**ASSESSMENT OF THE  
FISH PASSAGE FACILITIES  
AT  
LAKE LODI IN THE MOKELUMNE RIVER**

**September 1992**

**David A. Vogel  
Senior Biologist  
Vogel Environmental Services  
21600 Wilcox Road  
Red Bluff, California 96080**

Figure 24. Cross-sectional profile of Woodbridge Irrigation District fish screen concrete support pier showing existing condition (left) and recommended modification to eliminate pier nose (right).

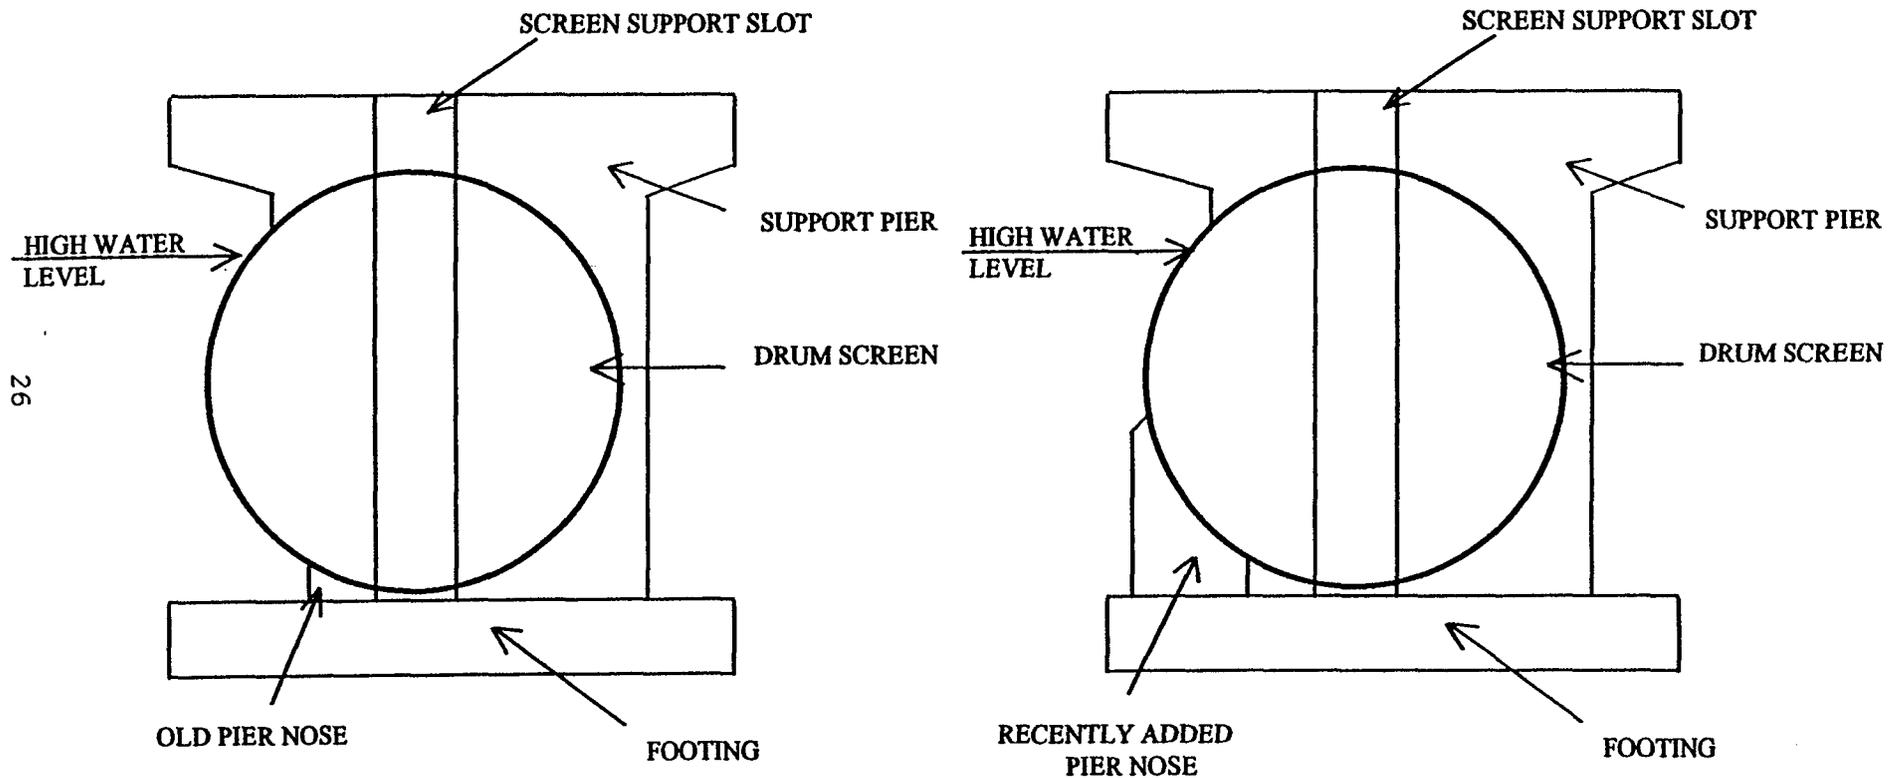
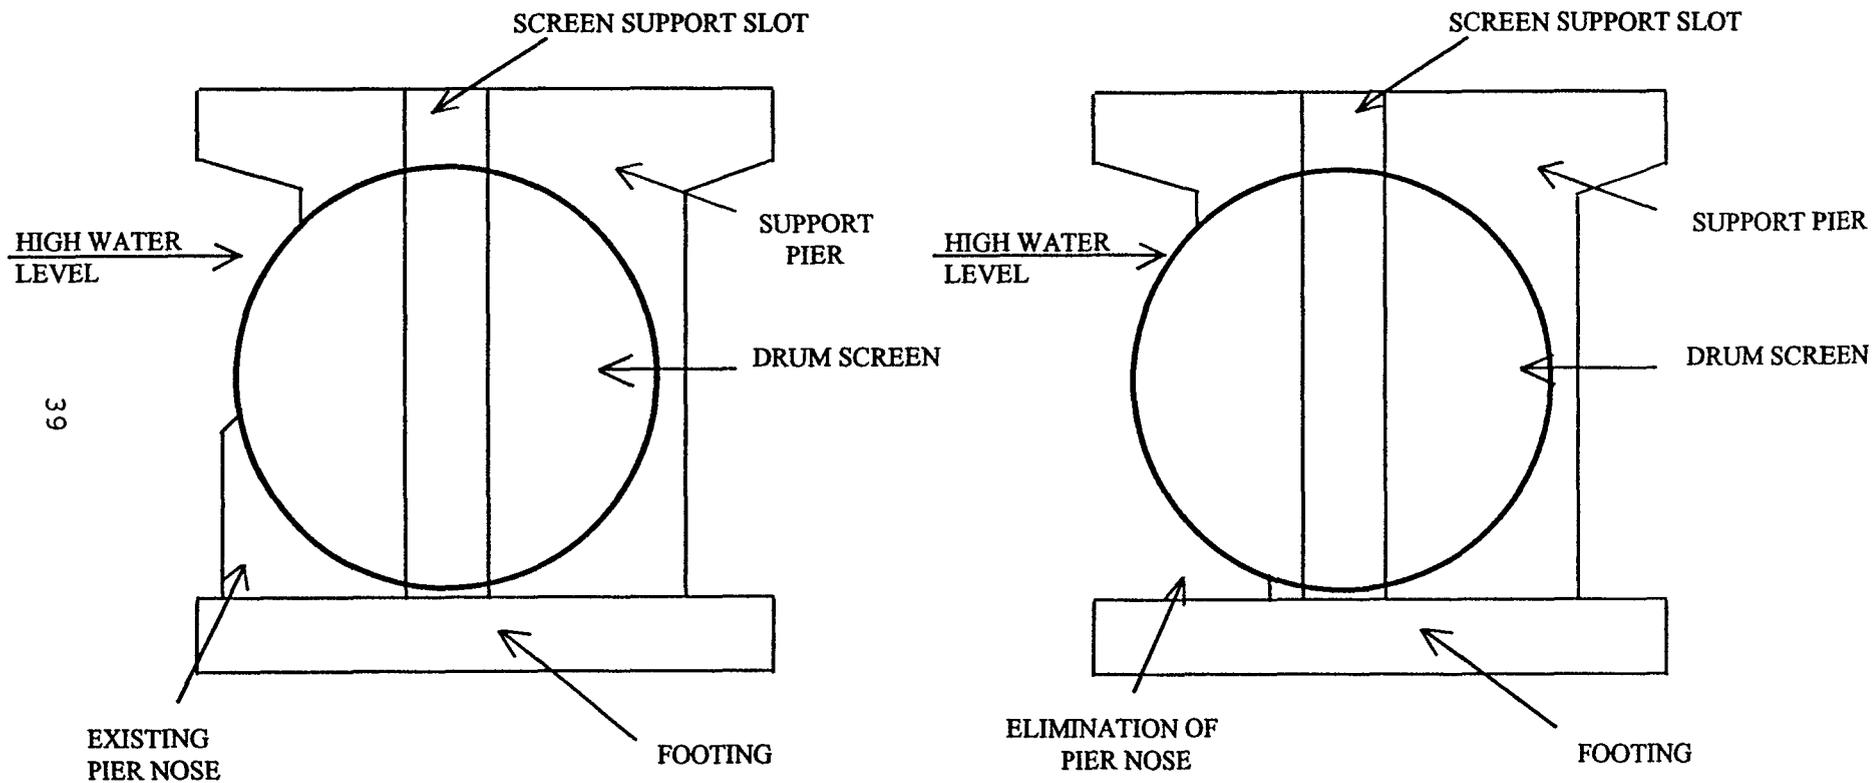
In examining the original design drawings for the WID fish screen structure, it is apparent that a relatively recent addition to the pier noses was made following original construction. The original pier noses were positioned close to the base of the fish screens whereas the addition onto the piers extended the pier noses approximately 5 feet in front of the base of the fish screens (Figure 20). It is not known why this modification was made to the structure, but doing so created worse conditions for fish than were present with the original design.

The pier noses added to the fish screen support structure since original construction should be eliminated as shown in Figure 24. This measure will improve conditions for young fish traversing the screens to the fish bypass system and eliminate fish entrapment zones. It will help improve tangential flow past the screens to the fish bypass system and thereby improve fish transport to the fish bypass. The purpose for this measure is to eliminate locations in front of the fish screens where young fish would have to swim upstream (i.e., against the current) to escape hazardous areas. Removal of the pier noses will help minimize fish exposure time to the screens and allow easier access by fish to the bypass system. Reduction in fish exposure time in front of the screens will help reduce the potential for predation, impingement, and entrainment.

Figure 21. Front view of the trashrack and slotted board used at the entrance to the Woodbridge Irrigation District fish screen bypass.

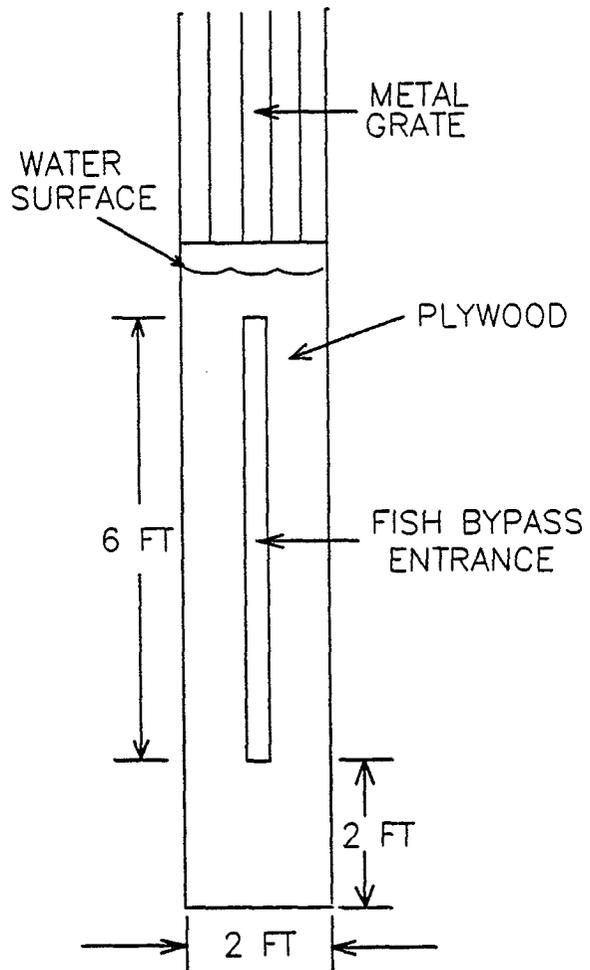
The entrance to the fish bypass system was inspected during the site visit on March 23, 1992 prior to the filling of Lake Lodi. The entrance is adjacent to the downstream-most fish screen (Figures 12, 13, and 19). Within the bypass, a large vertical trashrack was present. Mounted to the trashrack was a plywood board with a notch 6 ft high by 3 1/16 inches in width (Figures 21 and 22). The bottom of the rack was positioned on top of an additional piece of wood which resulted in the bottom of the notch being positioned 2 feet off the concrete floor (Figure 21). It appears that the plywood board was not an original feature of the fish bypass system and was simply lashed onto the vertical metal trashrack grates. This added feature in front of the bypass is unusual because it is a generally accepted practice to avoid such abrupt flow transitions and narrow entrances into a fish bypass system. Juvenile fish are extremely

sensitive to changes in hydraulic conditions (Rainey, 1985). Niggel (1964), as cited by Rainey (1985), found that fish response to a flow acceleration in a uniform channel with a flow constriction at the lower end resulted in fish holding upstream of the point of flow acceleration. These conditions would make the young fish highly susceptible to predation by predatory fish.

The slotted plywood board over the fish bypass entrance should be removed during periods when the bypass system is intended to function as designed. The constriction in flow and width of the entrance into the bypass system very likely impairs the effectiveness of the system.

The configuration of the bypass entrance should be altered from a bottom water intake to a surface water intake. This will allow for more desirable entrance conditions by allowing downstream migrant fish to initially enter the system from the surface (where they are more naturally oriented through behavioral tendencies), rather than forcing an initial downward guidance of fish into the entrance.
